*Southern California Edison Company*

Subject: Docket No. 50-206  
NUREG-0737 Item II.D.1-Performance Testing of  
Relief and Safety Valves  
San Onofre Nuclear Generating Station  
Unit 1

RESPONSES TO NRC QUESTIONS ON  
PRESSURIZER RELIEF AND SAFETY VALVE TESTING  
SAN ONOFRE NUCLEAR GENERATING STATION  
UNIT 1

Feedline Rupture 250 gpm @ 15 min.

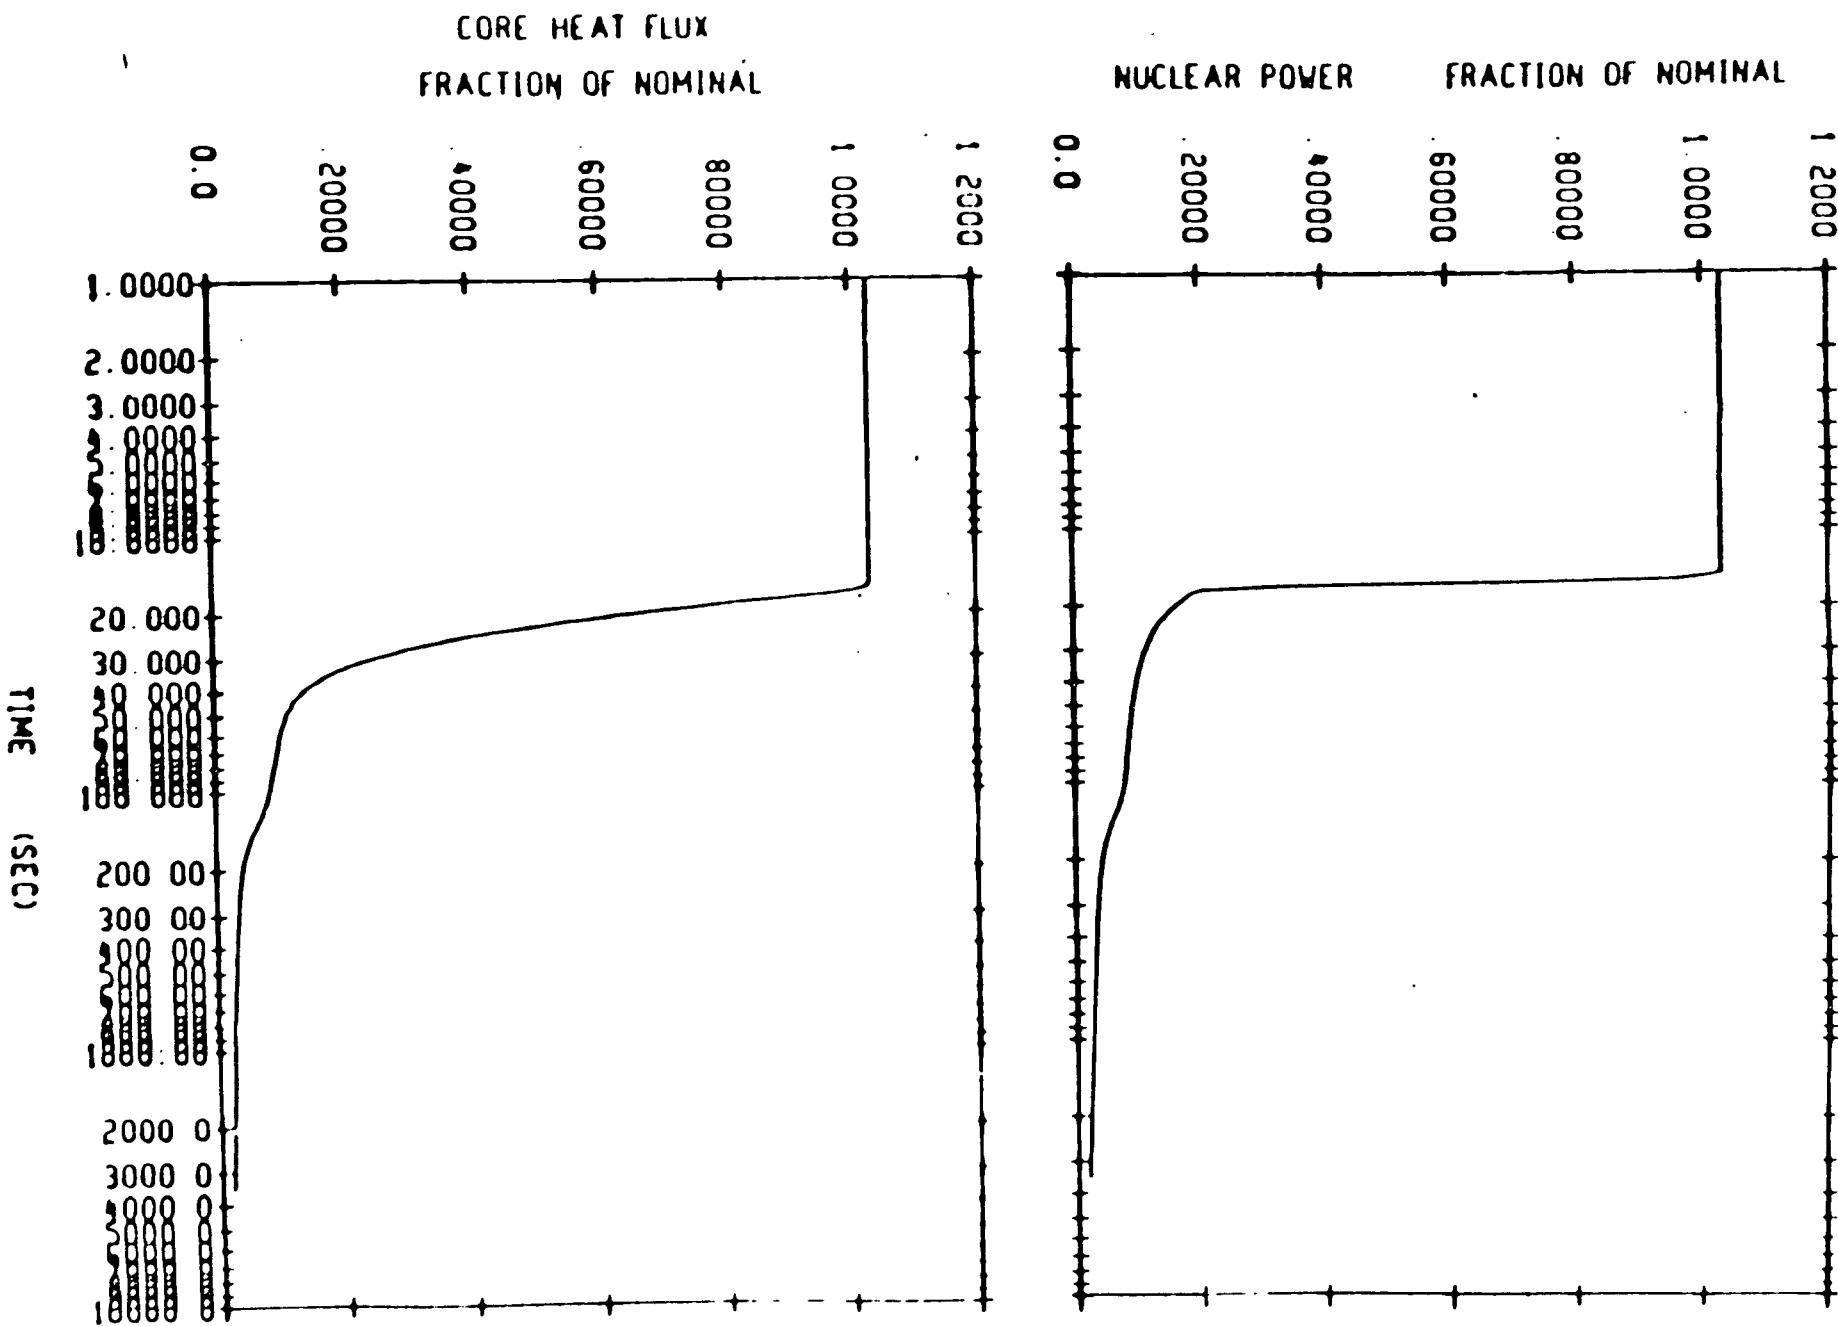
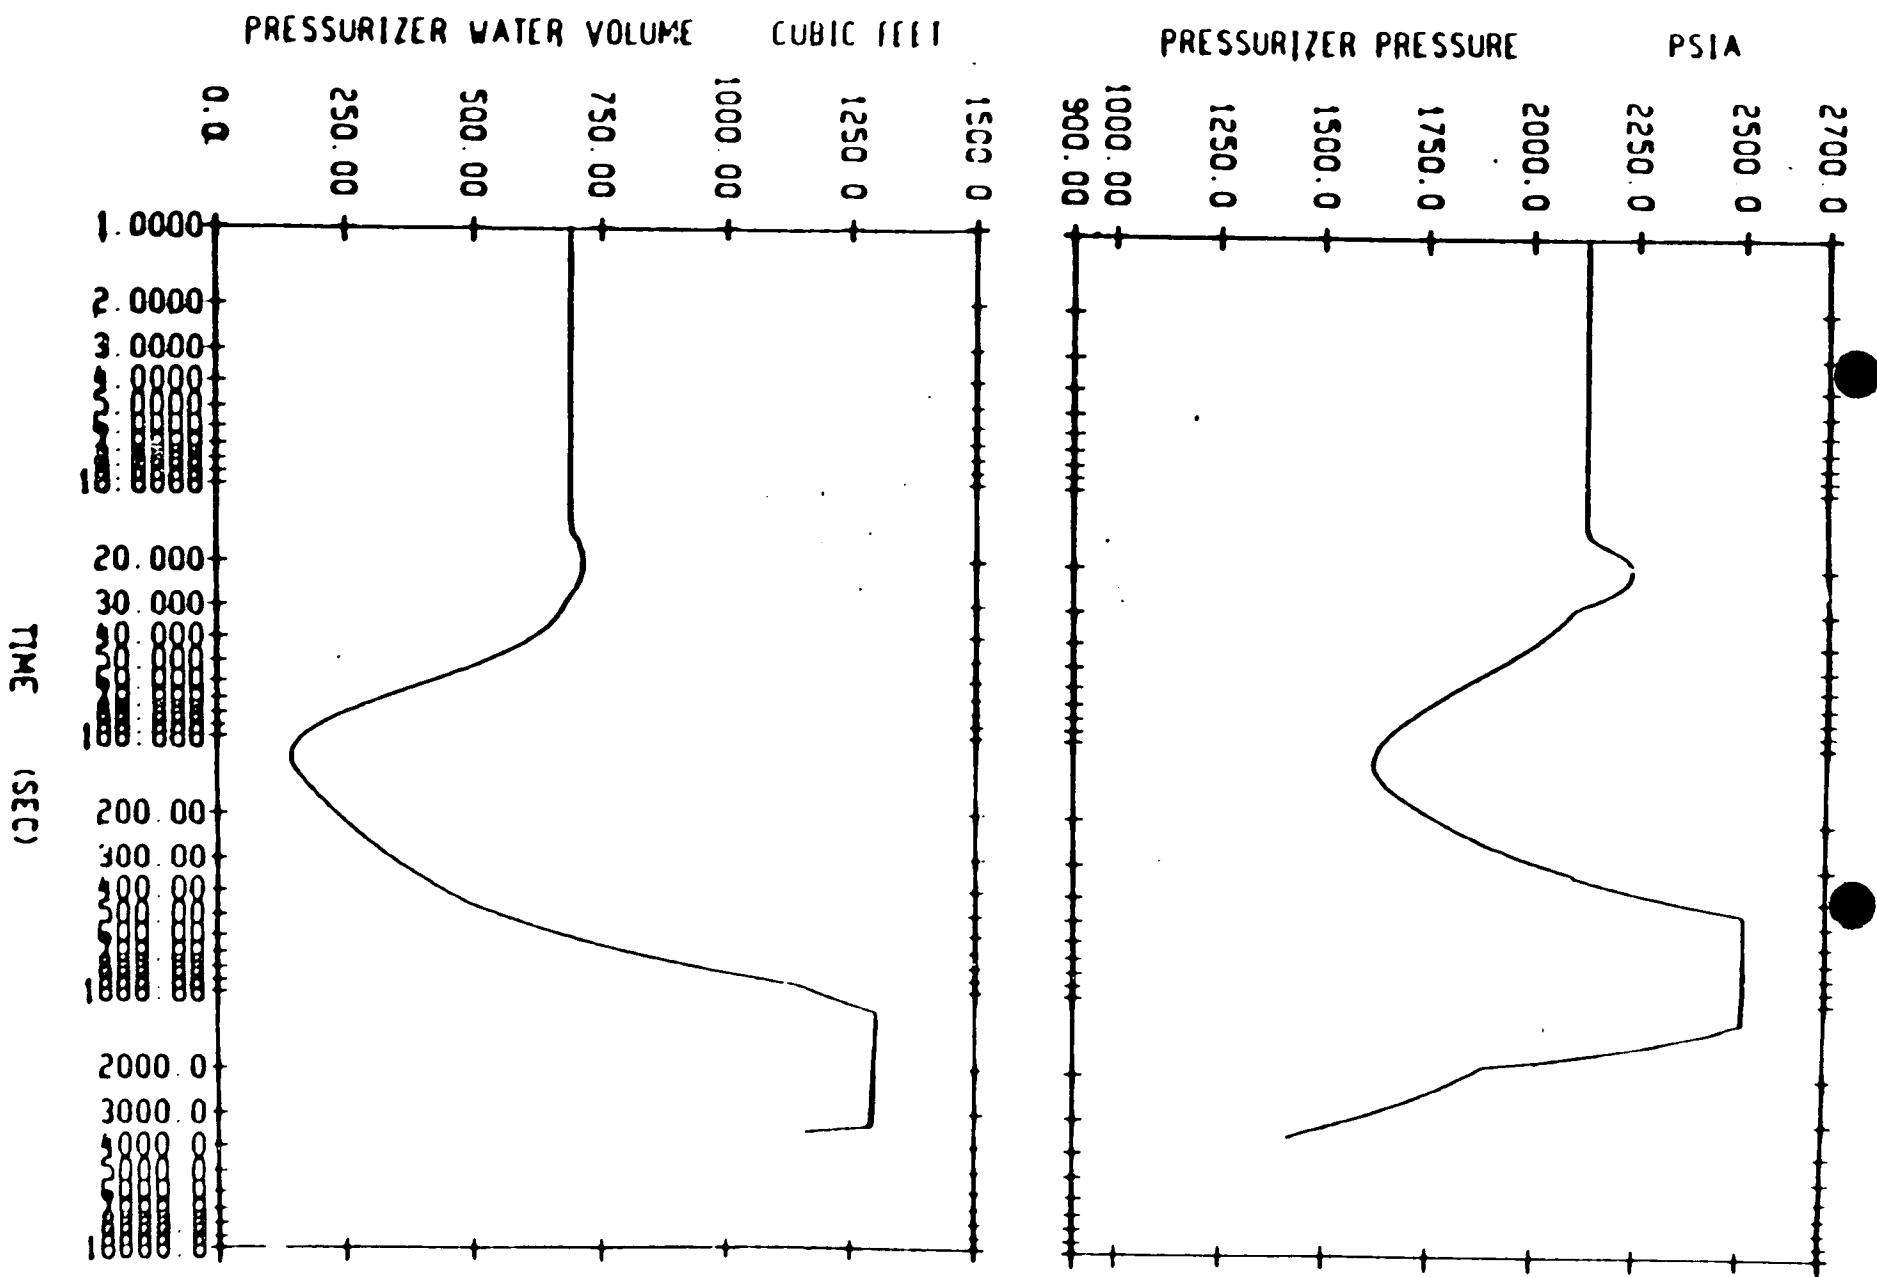
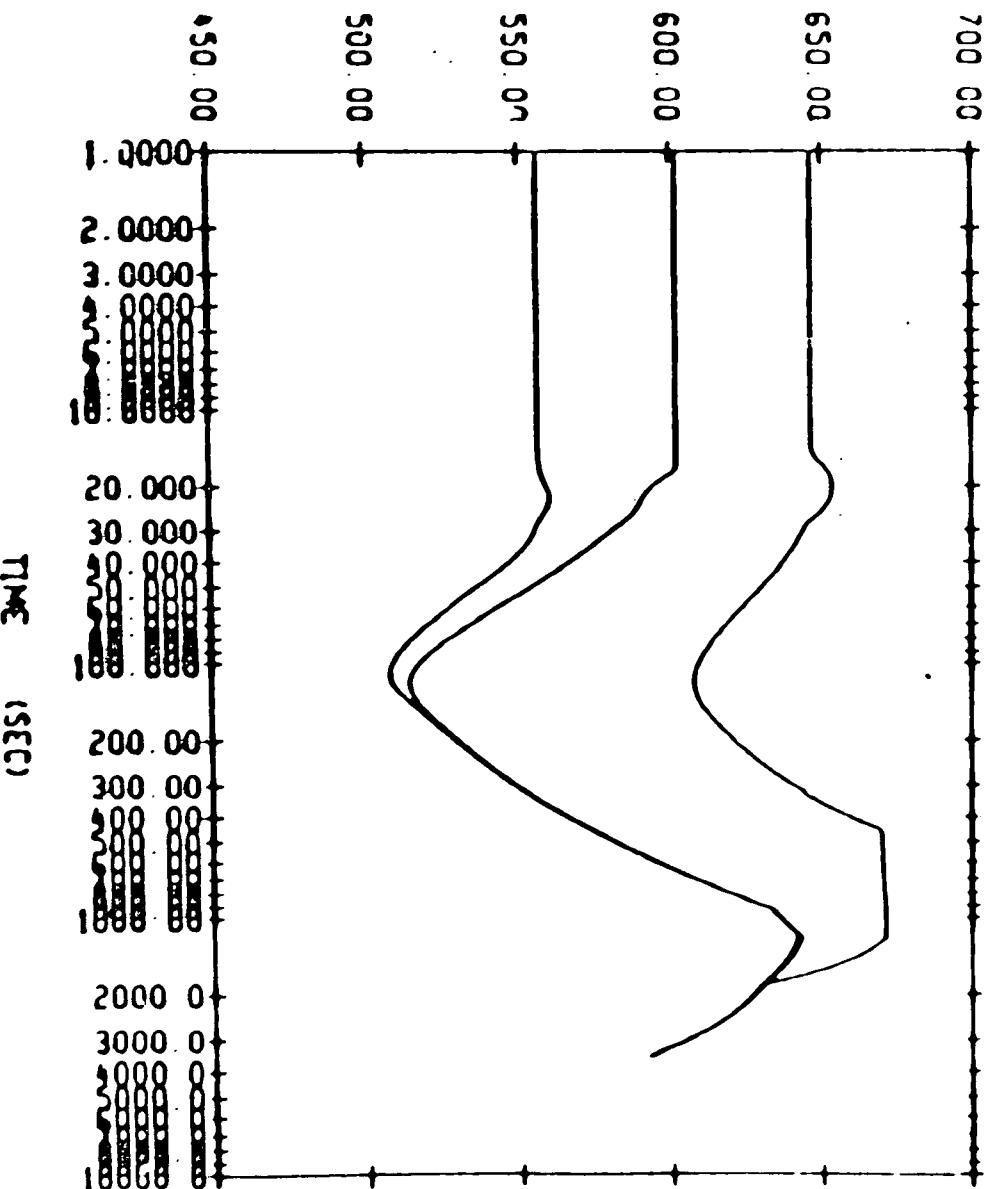
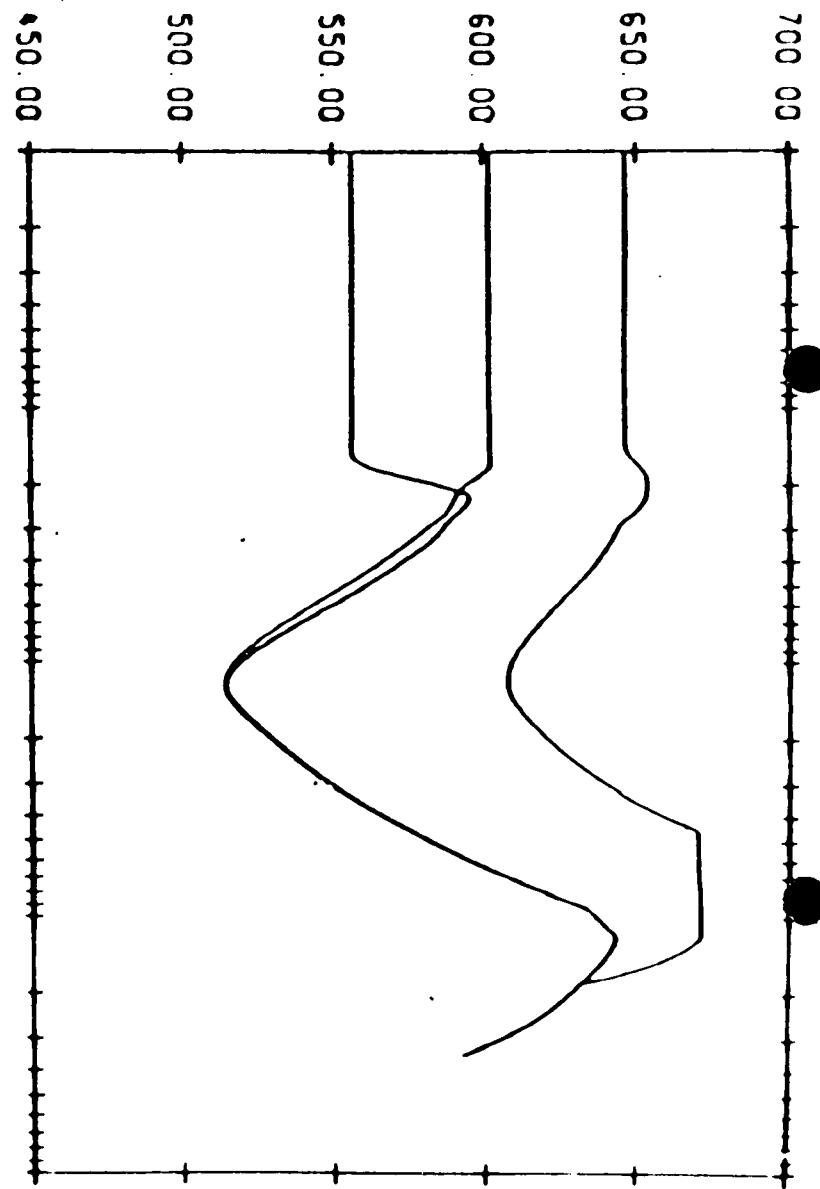
The Westinghouse valve inlet fluid conditions report stated that liquid discharge through both the safety and relief valves is predicted for an FSAR feedline break event. The Westinghouse report gave expected peak pressures and pressurization rates for some plants having an FSAR feedline break analysis. San Onofre 1 was not included in this list of plants having such an FSAR analysis. Nor does the submittal address the feedline break event. NUREG-0737, however, requires analysis of accidents and occurrences referenced in Regulatory Guide 1.70, Revision 2, and one of the accidents so required is the feedline break. Provide fluid pressure and pressurization rate, fluid temperature, valve flow rate, and the time duration for the feedline break event. Provide assurance that the valves passed water for a sufficient duration during the tests to cover this event and furnish an analysis which demonstrates safety of the safety/relief valve system for the feedline break event.

In response to post-TMI requirements, a feedline break analysis was performed and submitted to the NRC under the subject of Automatic Initiation of Auxiliary Feedwater Systems by letters dated March 6, 1981 and November 18, 1981. This analysis was reviewed and approved by the NRC as part of TMI Item No. II.E.1.1 and documented in NRC Amendment No. 65 dated October 2, 1982. The feedline break analysis was also reviewed and approved by the NRC as part of SEP Topic XV-6, Feedwater System Pipe Breaks Inside and Outside Containment (PWR), letter dated March 3, 1982 and XV-5, Loss of Normal Feedwater Flow, letter dated March 14, 1983.

The limiting feedline break analysis for San Onofre Unit 1 assumes auxiliary feedwater flowrate of 250 gpm and operator action time of 15 minutes after reactor trip. The appropriate plots of pressure, temperature and flowrates are attached. The defined "acceptable results" considered no bulk boiling in

the primary system prior to the time of loop temperature turnaround, i.e., the time when the heat removal rate equals the heat input on the primary side. Note that the peak pressurizer water volume is approximately 1299 cubic feet and the pressurizer capacity is 1300 cubic feet. Based upon these results, the limiting feedline break transient does not result in a solid pressurizer; thus, water relief is not predicted.
